**Surplus Plutonium Disposition
Supplemental Environmental
Impact Statement**

Volume 3
Comment Response Document

U.S. Department of Energy
Office of Material Management and Minimization
and
Office of Environmental Management
Washington, DC

Figure 1. Tectonic Map of the LANL Region. Source: Figure 3-2 in LANL 2007 PSHA Report.

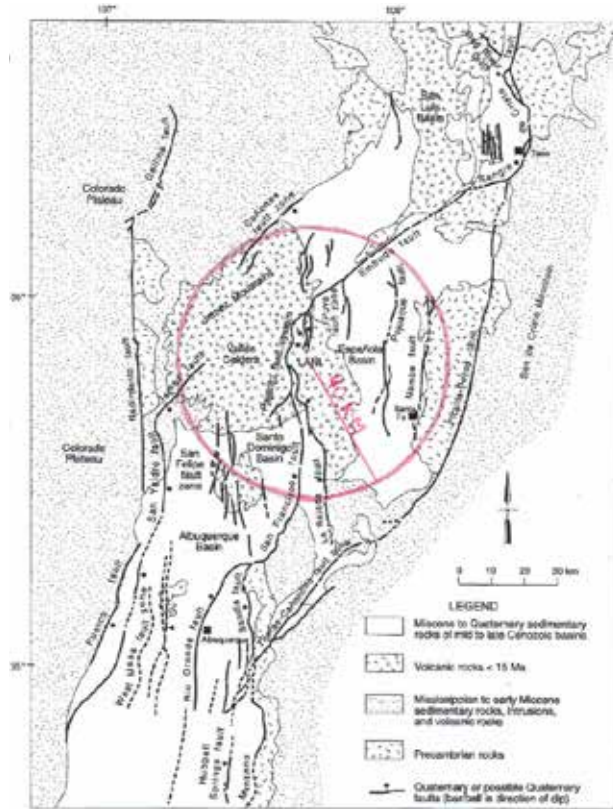
LANL is located within an intracontinental seismically active subduction zone, named the Rio Grande Rift. A tectonic map of the network of faults in the Rio Grande Rift is in Figure 1. Figure 1 shows that a super volcano, the Valles Caldera, sits to the west of LANL; it is similar to the super volcano that formed Yellowstone National Park and surrounding areas. Both super volcanoes are now collapsed calderas and have "youthful" fault systems on their flanks because of the huge volcanic eruptions. Geologists expect both super volcanoes to erupt at some time in the future. To the east of the 40-square mile laboratory is the Rio Grande, a source of drinking water for Santa Fe and Albuquerque.

The red circle on Figure 1 displays the Quaternary Faults within 40 km of LANL. However, the LANL PSHA only included the Embudo Valley Fault System/Southwest to the north of the PFS, and the PFS as described in the excerpt above without the Sawyer Canyon Fault (see discussion below on page 6 about the omission of the Sawyer Canyon Fault).

ANSI/ANS-2.27-2008 requires detailed field investigations of all faults displayed on Figure 1 that are within a 40-km (24-mile) distance of the PF-4 but the required field investigations were not performed for the following faults displayed on Figure 1: (1) the Nambe Fault at Santa Fe, (2) the La Bajada Fault, (3) the San Francisco Fault, (4) the San Felipe Fault Zone, (5) the Jemez Fault, (6) the Cahones Fault, (7) the Santa Clara Canyon Fault (see Figure 2), (8) the Puye Fault Zone, and (9) the Pojoaque Fault. A 3.5 magnitude earthquake occurred

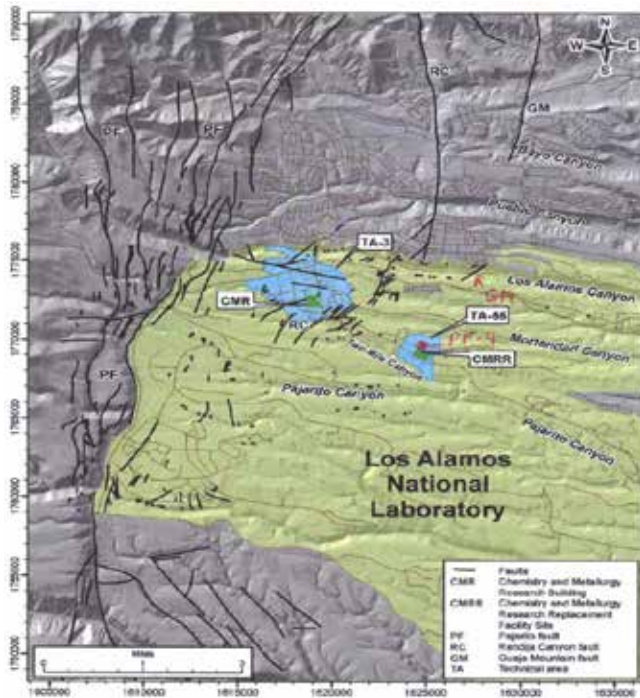
Detailed geologic mapping of the area between the mapped southern termination of the Guaje Mountain Fault [GM Fault on Figure 3] and the northern side of Los Alamos Canyon [a north-south distance greater than 6,300 ft] has not yet been undertaken (DOE Response to Comment 315-5).

In the above statement, DOE admits the very serious omission of detailed field mapping for location of the GM Fault. Nevertheless, the DOE 2011 final SEIS misrepresents the key GM Fault to terminate at a distance 2 ½ miles north of the proposed CMRR-NF. In fact, the GM Fault is the fault segment on Figure 3 at land surface in Los Alamos Canyon within a distance of 4,000 ft from the PF-4. In addition, the large zone of intense fractures ~800 ft west of the PF-4 on Figure 4 is evidence of ground shaking from the close location of a concealed active fault that is probably the RC Fault, but is possibly the GM Fault. The best information is that the GM Fault is the concealed active fault located ~2,000 ft east of the PF-4 (see Figures 3A and 3B).

DOE and the LANL scientists admit that the active GM Fault is much closer to the proposed CMRR-NF and the PF-4 than the 13,000 ft (2 ½ mile) distance on Figure 3 that was used to calculate the seismic hazard at the PF-4. As described above, the GM Fault is the 1,800-ft long unnamed fault segment on Figure 3 present at land surface in Los Alamos Canyon 4,000 ft north of the PF-4. A very important fact is that three LANL reports published in 1985, 1990 and 2004 identified that the RC Fault is the concealed active fault ~800 ft west of the PF-4 and the GM Fault is the concealed active fault located ~2,000 ft east of the PF-4 (See Figures 3A, 3B, 4 and 5). Omission of the close locations of the active concealed faults in the seismic hazard analysis for the PF-4 threatens workers, the public and the environment because of the much greater ground motions at the PF-4 from the close locations of the concealed active faults.

- 2) the DOE 2011 final SEIS incorrectly described the GM fault to terminate based on surface expression ~11,000 ft north-northeast of the PF-4 (see discussion above on page 7). However, Figure 3 shows the surface expression of the GM fault as being within ~4,000 ft of the PF-4;

**Figure 3A.** One possible scenario for the concealed active RC Fault located ~800 ft west of the PF-4 and the concealed active GM Fault located ~2,000 ft east of the PF-4.

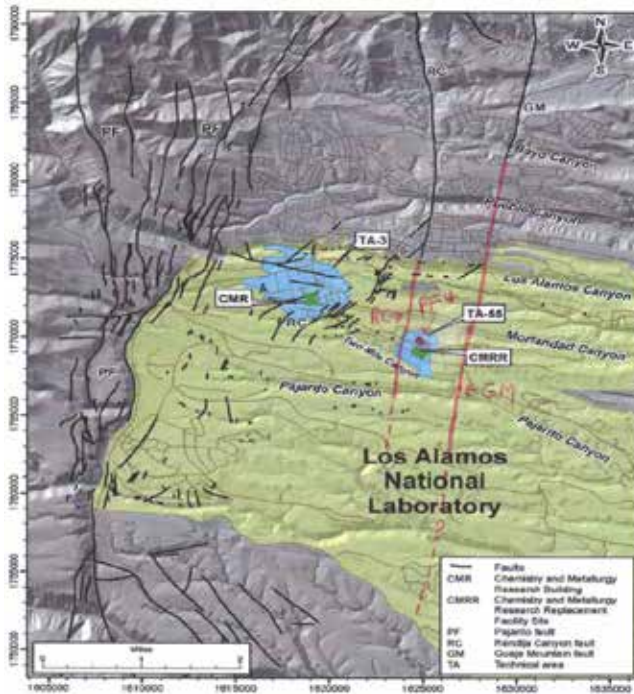
- 3) moreover, Figures 3A, 3B, 4 and 5 show the close distance of the concealed active RC and GM faults ~800 ft west and ~2,000 ft east of the PF-4, respectively; and

**Note:** The concealed faults are displayed in red and dashed where inferred. The concealed faults were not included in the seismic hazard analysis for the PF-4. See Figures 4 and 5.

**Figure 3B.** A second possible scenario for segments of the concealed active GM Fault located ~800 ft west and ~2,000 ft east of the PF-4. In this scenario, the concealed active RC Fault is located ~1,400 ft northwest of the PF-4.

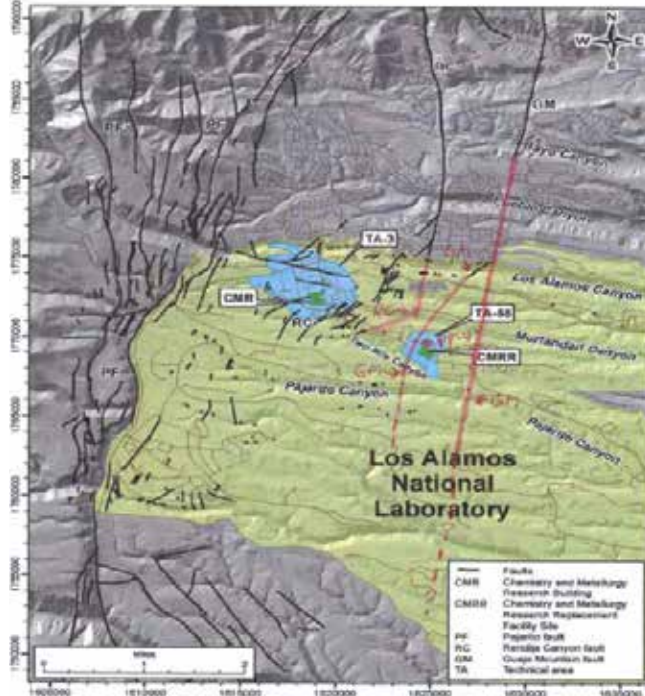
**Note:** The concealed faults are displayed in red and dashed where inferred. The concealed faults were not included in the seismic hazard analysis for the PF-4. But LANL Reports published in 1985 and 2004 show the concealed faults close to the PF-4. See Figures 4 and 5.

**Figure 4.** Map showing the locations of the two east-west seismic reflection lines; line 1 in Los Alamos Canyon and line 2 in Mortandad Canyon.

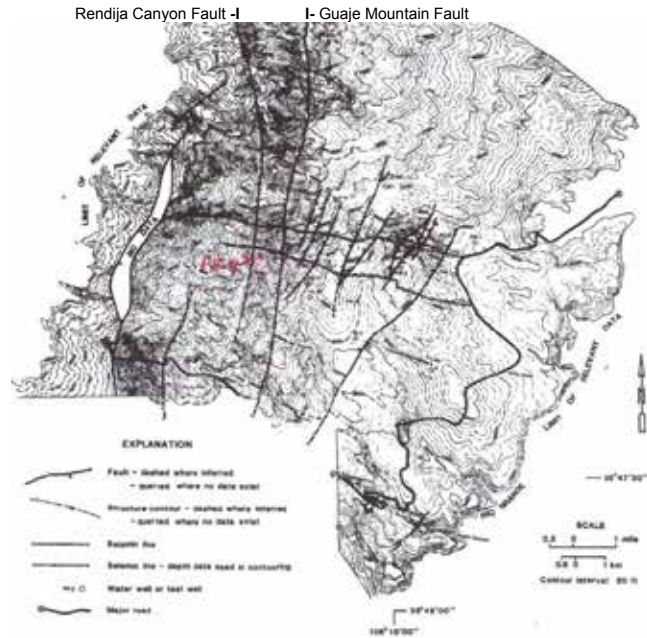
Figure 4 is map 1 in the 1985 LANL report by Dransfield and Gardner. The map shows the locations of the two east-west seismic reflection lines; line 1 in Los Alamos Canyon and line 2 in Mortandad Canyon. The two seismic lines reliably detected the concealed active RC and GM Faults to be present below Mortandad Canyon located ~ 1,500 ft to the north of the PF-4. Further, the detailed mapping of zones of intense fractures in the Bandelier Tuff by Wohletz (2004) (see Figure 5) confirmed that the concealed active RC Fault is located ~ 800 ft west of the PF-4 and the concealed active GM Fault is located ~2,000 ft east of the PF-4.

The detailed field investigations for accurate knowledge of the dip and “sense of slip” for the faults with surface displacements on Figure 3 and the concealed faults on Figure 4 have not been performed. However, the 1985 LANL report by Dransfield and Gardner shows that seismic reflection surveys will provide important information on the geometry of the discrete faults in the PFS.

**Note:** The two 1979 seismic lines reliably detected the concealed active RC Fault to be present within ~800 ft to the west of the PF-4 and the concealed active GM Fault to be present within ~2000 ft to the east of the PF-4. The detailed mapping of zones of intense fractures in the Bandelier tuff in 2004 (see Figure 5) confirmed that the concealed RC and GM Faults identified by the two seismic reflection lines were active faults.

Figure 5. Map showing the zones of intense fractures at land surface in the Bandelier Tuff.

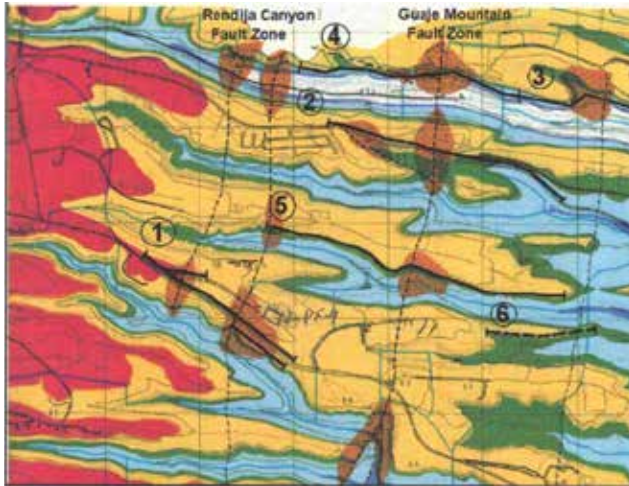
- (1) Examination for potential Quaternary surface faults at the site or for Quaternary faults that trend toward the site [e.g., RC and GM Faults];
- (2) evaluation of the activity and origin of any Quaternary faults detected at the site or in the site vicinity that trend toward the site and the history of their displacement by the use of appropriate and accepted techniques and methods;
- (3) Evaluation of the width of the Quaternary fault zone, including areas of possible secondary ground deformation [e.g., the zones of intense fractures above the concealed RC and GM faults (see Figure 5)] (p.15 in ANS-2.27-2008).

Source: Figure 14 in *Tuff Fracture Characterization Along Mortandad Canyon Between OU-1114 and OU-1129*, (LANL Report No. LA-UR-04-8337, 2004) by K. H. Wohletz,  
 - The north-south trending fault ~800 ft west of the PF-4 is the inferred location of the buried active Rendija Canyon (RC) Fault.  
 - The north-south trending fault zone ~2,000 ft east of the PF-4 is the inferred location of the buried active Guaje Mountain (GM) Fault. The close locations of the buried active RC and GM faults were not considered in the engineering design for the seismic upgrades to the 1970's era LANL Plutonium Facility PF-4.

**Figure 6.** Comparison of the larger seismic hazard from synchronous versus simultaneous ruptures at the LANL Plutonium Nuclear Facility PF-4 at LANL TA-55 for a 2,500 year return period. **Source:** Figure 7-53 in LANL 2007 PSHA Report.

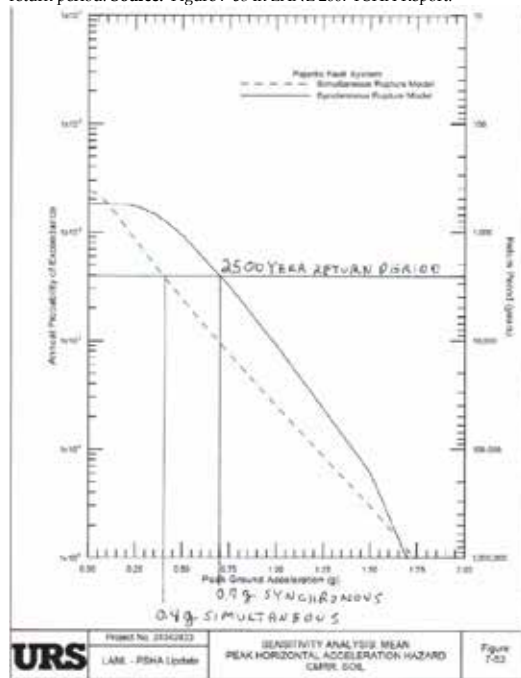
Figure 7-53 in the 2007 PSHA (see Figure 6 in this report) presents the results from computer modeling that show synchronous earthquakes to produce 75% greater ground motions at the PF-4 than the values used for the engineering design of the seismic hazard upgrades from a single earthquake of M 7.0. A very serious mistake is that even the insufficient data and discussion in the LANL 2007 PSHA show that the DBE should be based on **synchronous earthquakes** that produce estimated horizontal and vertical ground motions at the PF-4 with minimum values of 0.82 g and 0.89 g, respectively for earthquakes with a return period of 2,500 years.

Nevertheless, Figure 7-53 in the LANL 2007 PSHA (see Figure 6) presents the results from the LANL computer models that show the synchronous earthquakes produce power for ~ 75% more destructive peak accelerations (i.e., ground motions) at the PF-4 for earthquakes on a return period of 2,500 years and ~ 50% more destructive ground motions for a return period of 10,000 years. It is a serious omission that the engineering design of the proposed seismic hazard upgrades for the PF-4 was not based on the very great ground motions from synchronous earthquakes for a return period of 10,000 years which produce estimated ground motions of ~1.5 g according to Figure 7-53 in the LANL 2007 PSHA Report.

The above computer model in Figure 7-53 shows a much larger relative horizontal ground acceleration of 0.7g for synchronous ruptures of the PFS compared to a lower value of 0.4g for simultaneous ruptures of the PFS. Figure 7-53 shows that the Mean Peak Horizontal Ground Acceleration Seismic Hazard at the PF-4 is 75% larger for the multiple ruptures from synchronous earthquakes in the PFS for a return period of 2,500 years.
